From: Karen Beare [redacted]
Sent: 18 June 2019 22:33
To: Thuairé, Charles [redacted]
Cc: Bob Warnock [redacted]; Nicola Mayhew [redacted]; Susan Rose [redacted]; Michael Hammerson [redacted]; David Castle [redacted]; David Richmond [redacted]; Thomas Radice [redacted]; john beyer [redacted]; Marc Hutchinson [redacted]; Constantine Koritsas [redacted]
Subject: 2019/2584/P - Water House Boundary with Millfield Lane

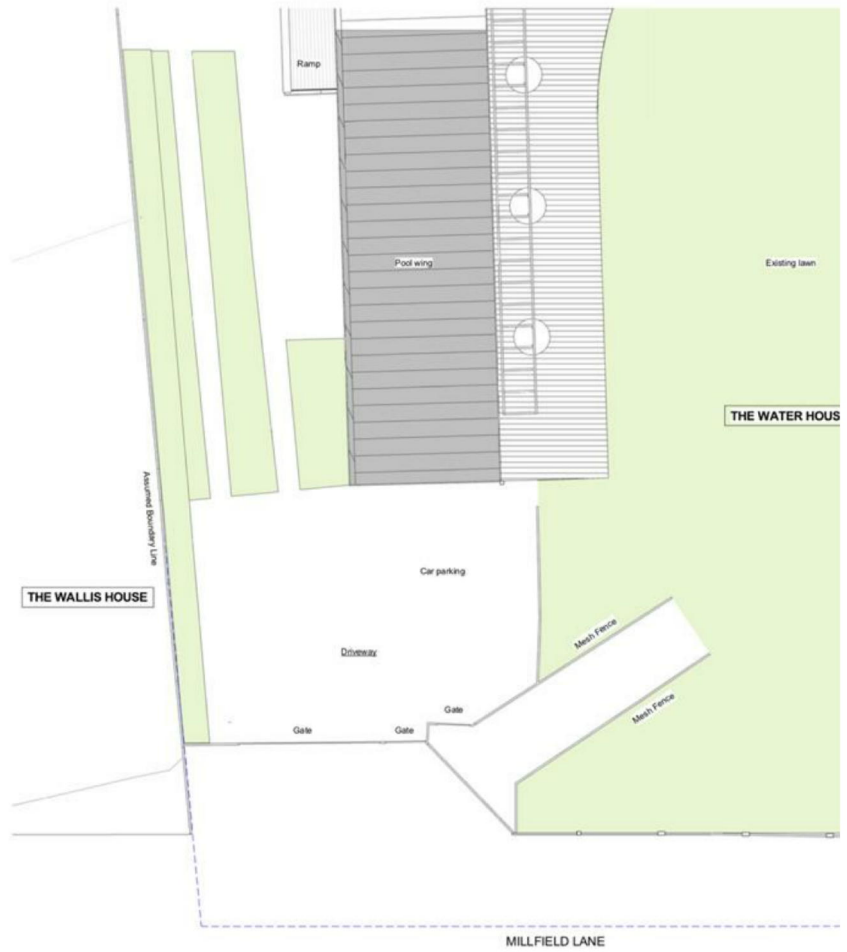
- The current driveway allows the driver of a car, exiting the site in forward gear, to nudge forward to see if there are any cyclists, pedestrians, runners, dogs etc coming from either direction, without the front of the car crossing the front boundary with the Lane. This provides a positive safety zone where the driver can see what's coming and then wait from a position from within the site until the coast is clear.

- The proposed driveway does not allow a driver to do this. Once the gate opens the driver will be entirely blind to any cyclists, pedestrians, runners, dogs etc coming from either direction, so will move forward directly onto the Lane unsighted because the existing front boundary has been moved forwards and the step-back arrangement removed.

- Conversely when entering the property the entire length of the car will stick out into the Lane causing an obstruction to any cyclists, pedestrians, runners, dogs etc coming from either direction for the length of time it takes the new bi-fold gates to open.

- this can be clearly seen by reviewing the two screenshots below. Regrettably no dimensions or levels are included on the drawings but the boundary is being brought forward towards the Lane by the gates by approximately 2m.
